# Origination Form

## Proposed Revisions to a Standard Plans Index

<b>Originator:</b>	Turley, Joshua	<b>Index Number:</b>	400-289
<b>Date:</b>	5/7/2024	<b>Sheet Number(s):</b>	3,5
<b>E-mail:</b>	Joshua.Turley@dot.state.fl.us	<b>Index Title:</b>	CONCRETE BOX CULVERT DETAILS

LAST REVISION	REVISION	DESCRIPTION: 11/01/2024	 FY 2024-25 STANDARD PLANS	CONCRETE BOX CULVERT DETAILS	INDEX 400-289	SHEET 3 of 8
01/01/07

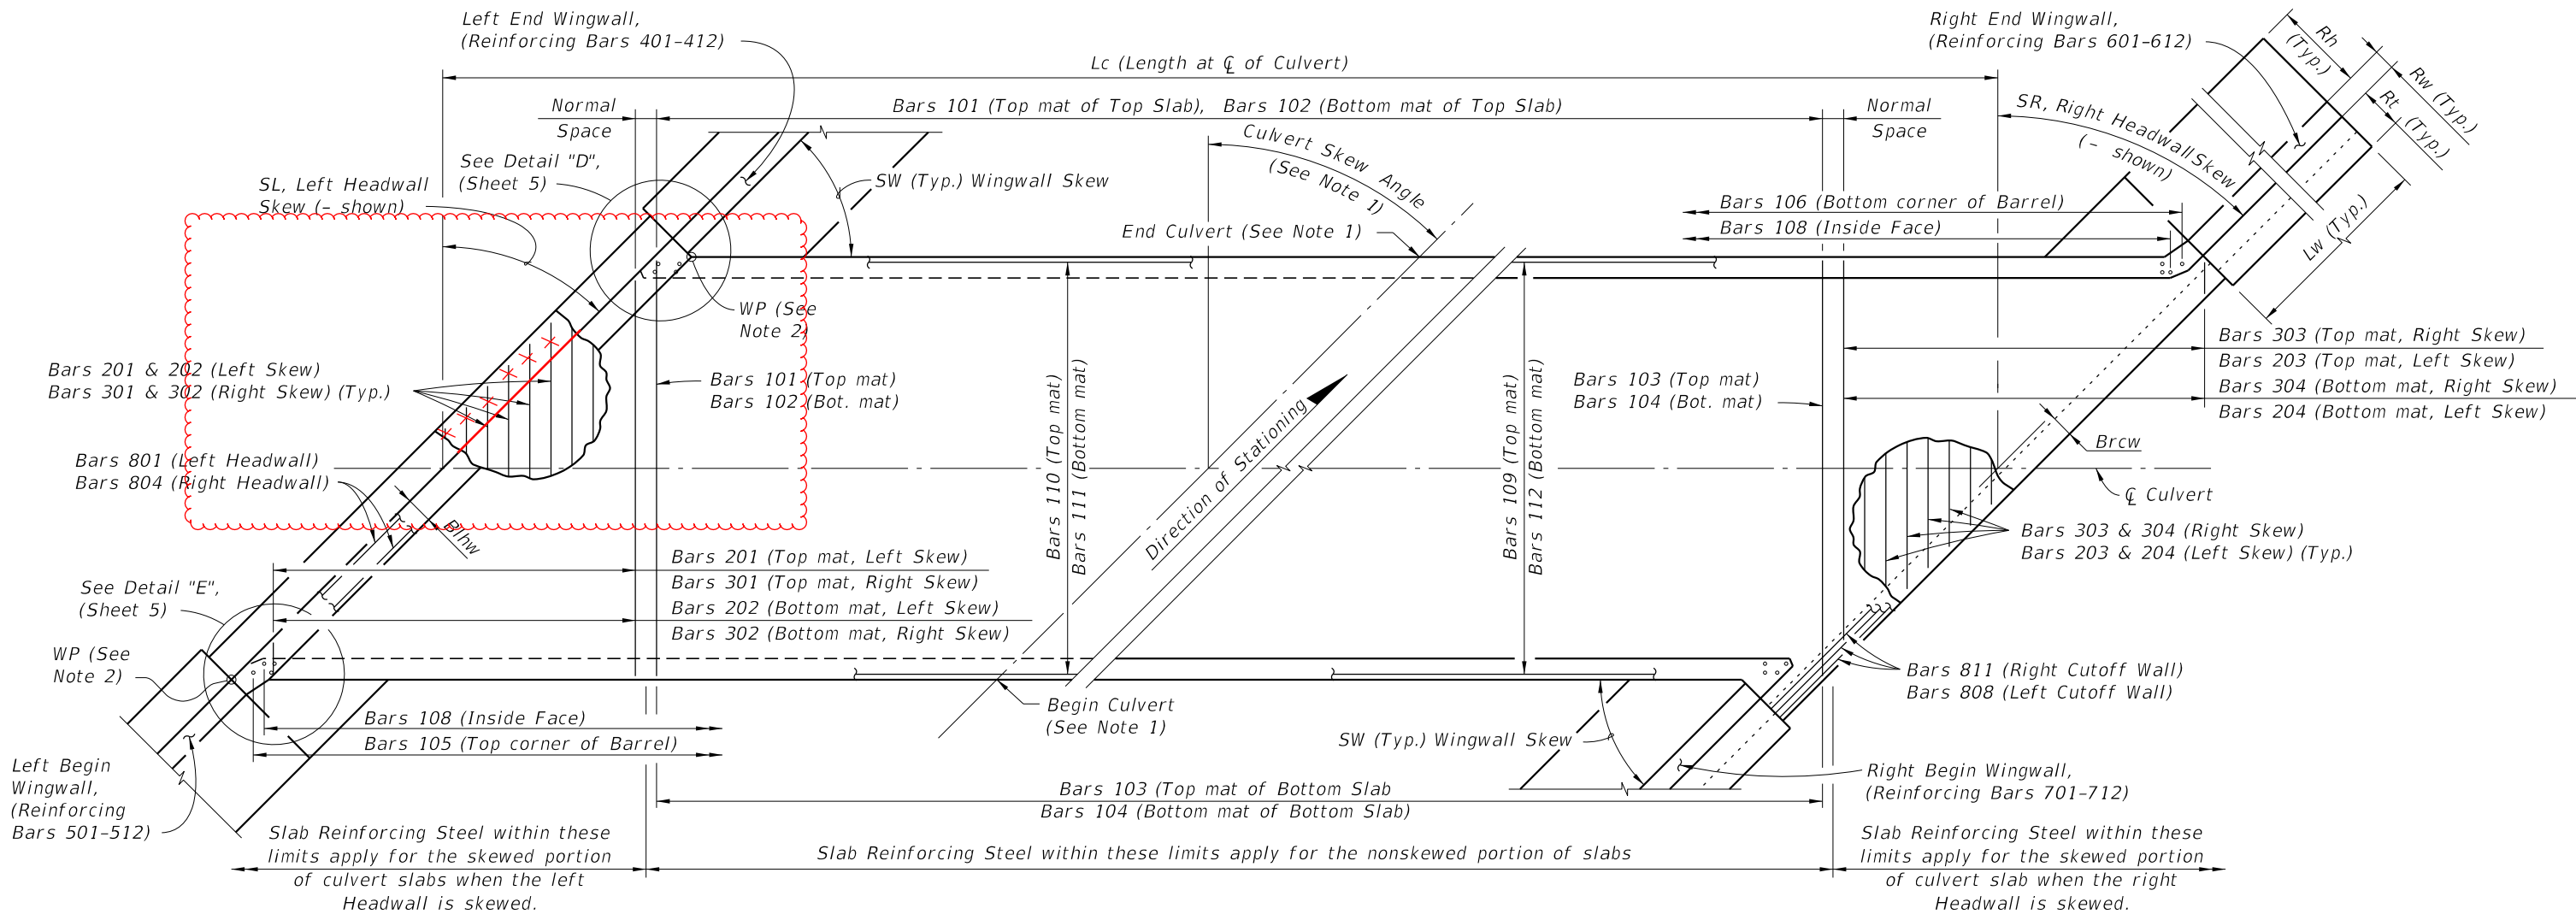
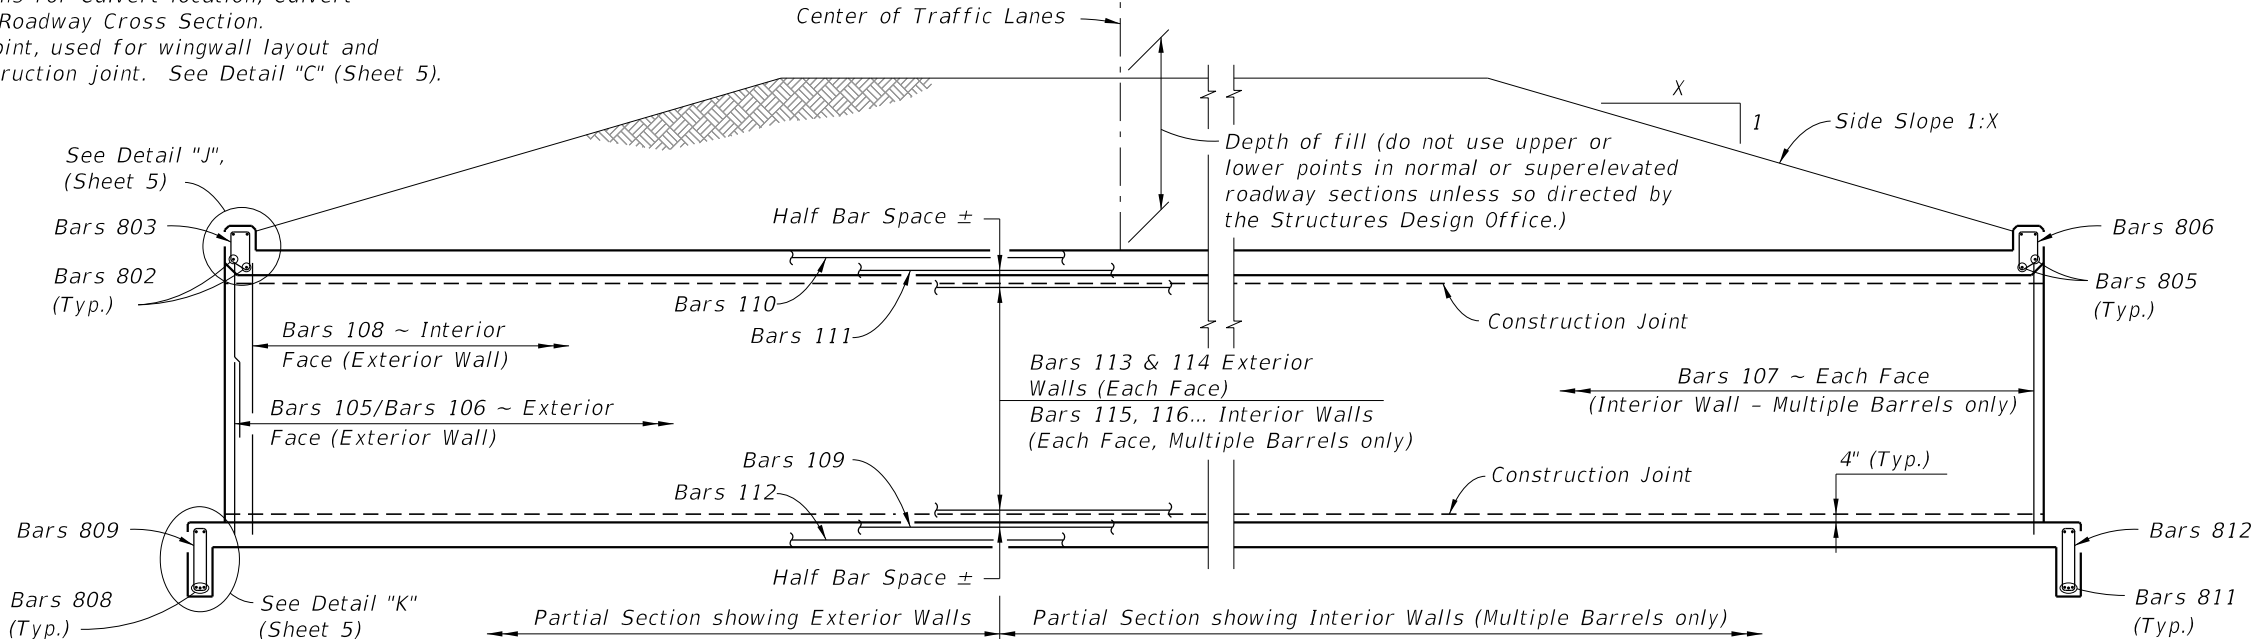
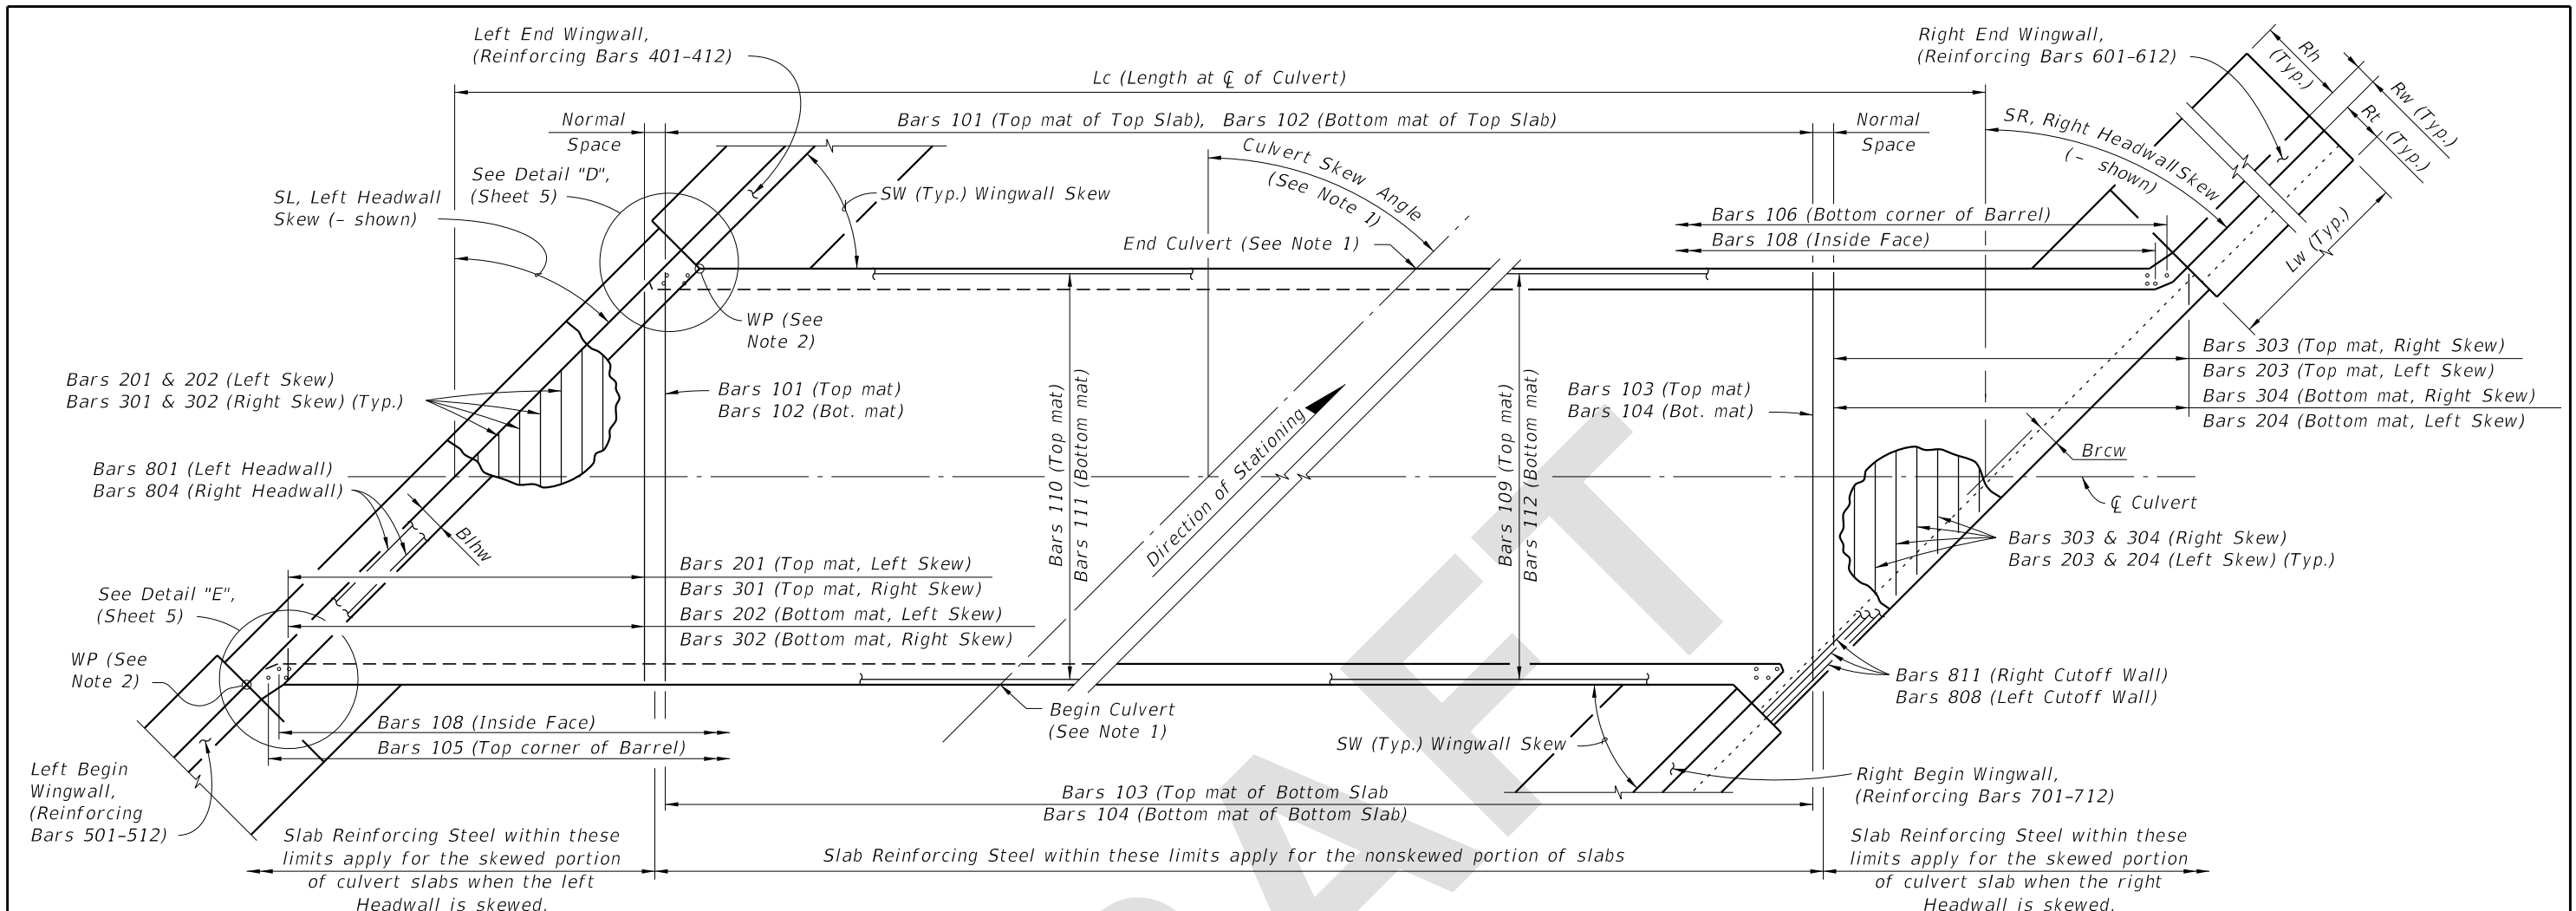
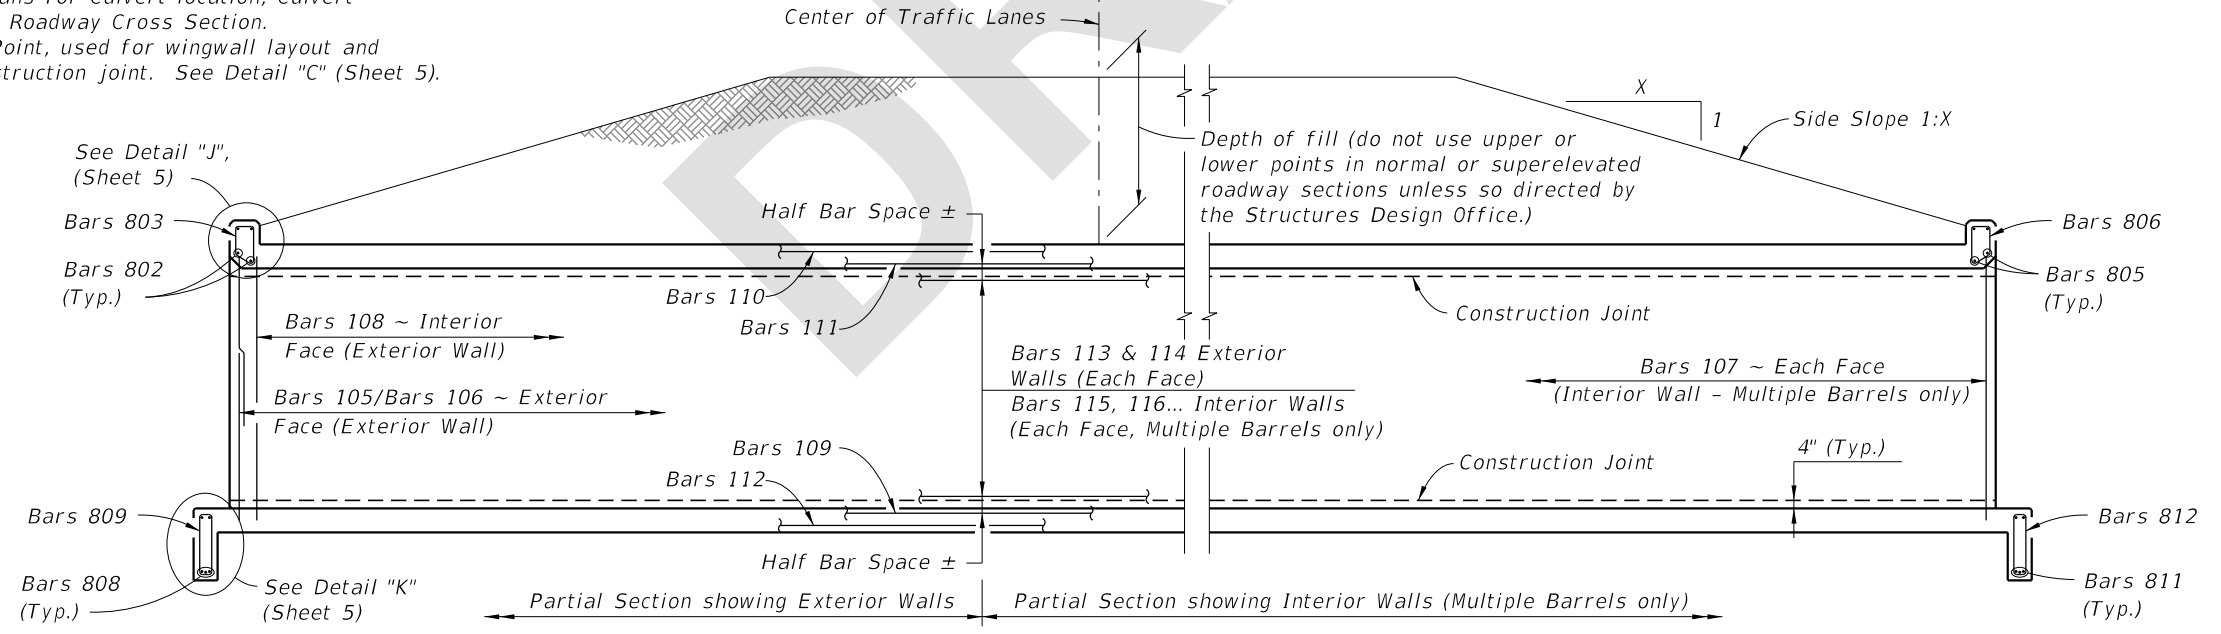
Sheet 3: Updated reinforcing in the PARTIAL PLAN TOP SLAB of SINGLE BARREL BOX CULVERT so it does not appear to extend into the footer below.  
 Sheet 5: Added some clarity to Note 2 and DETAIL "C" about the proper work point location (WP)

Sheet 3: This was a CAD error the lines didnt stop at the correct place making it appear as if the reinforcing should extend from the top slab through to the footer which is physically impossible as they are on two different elevations.  
 Sheet 5: There was some confusion about where the proper work points were for the wingwall construction joint. The labels didnt match the diagram so we corrected this.
